Subject: Final Report - DER 84-51
A 50.55(e) Reportable Condition Relating To Failure Of The
Turbine-Driven Auxiliary Feedwater Pump To Quick Start From
Ambient Conditions.
File: 84-019-026; D.4.33.2

FINAL REPORT - DER 84-51
DEFICIENCY EVALUATION 50.55(e)
ARIZONA PUBLIC SERVICE COMPANY (APS)
PVNGS UNITS 1, 2, 3

SKETCH FOR DER 84-51

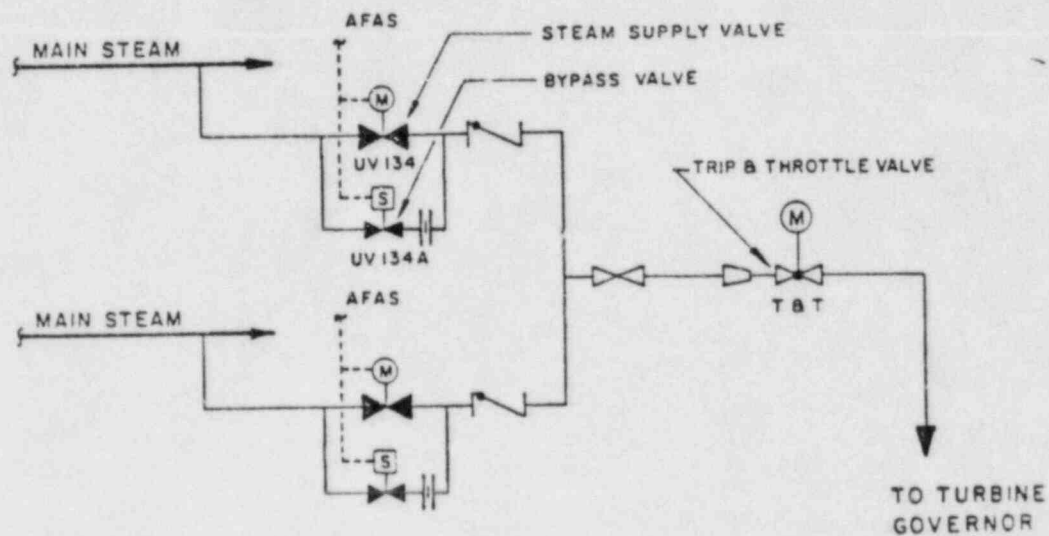
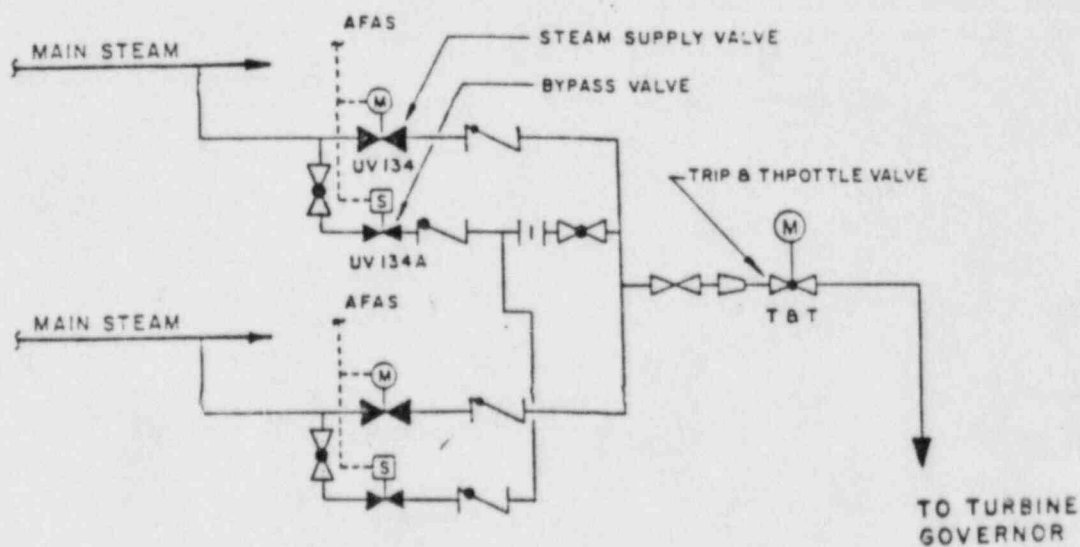
During an emergency shutdown condition, following the initiation of an AFAS, the steam supply valves receive a signal to open in order to start the steam turbine. Upon receipt of an AFAS signal, the solenoid-operated bypass valves open to bring the turbine up to idle speed prior to full steam admission. An adjustable Agastat relay provides a time delay prior to opening the supply valves. In the original design the idle speed was set at 1300 rpm and the steam supply valves opened five seconds after the solenoid bypass valves received a signal to open.

Evaluations have indicated that the five-second delay is not sufficient to allow for the warming up of the lines and pump casing and attain the turbine idle speed. Since the turbine speed control system maintains the governor valve in a full open position until the idle speed is reached, the start of main steam admission within five seconds after the initiation of a turbine startup command results in the entry of "ungoverned" steam flow to the turbine causing an overspeed condition and consequently the rapid closure of the trip and throttle valve.

1. The 5-second delay time has been changed to 10 seconds.
2. The discharge piping from the two solenoid bypass valves has been routed to a single orifice with an injection point closer to the turbine. This modification allows the sizing of a single orifice rather than two parallel orifices, as well as reducing the mass of pipe requiring heating before the turbine reaches idle speed. One orifice assures the same bypass steam flow to the turbine with one AFAS signal or two AFAS signals which corresponds to one steam admission valve or both steam admission valves opening.

The solution to this problem is to make the necessary design changes in order to establish the turbine idle speed and place the turbine on governor control prior to the admission of full steam flow. This objective is being accomplished by the implementation of the following modifications:

3. The idle speed was reduced from 1300 rpm to 800 rpm.
4. The governor ramp start has been delayed until the steam admission valves are full open. In the original design, the ramp began as soon as the admission valves came off their seat.

5. The condensate drains on both the turbine casing and the steam supply piping are being modified to increase the capacity of the low point drain system to eliminate the condensate generated during the warm-up period prior to a cold start.
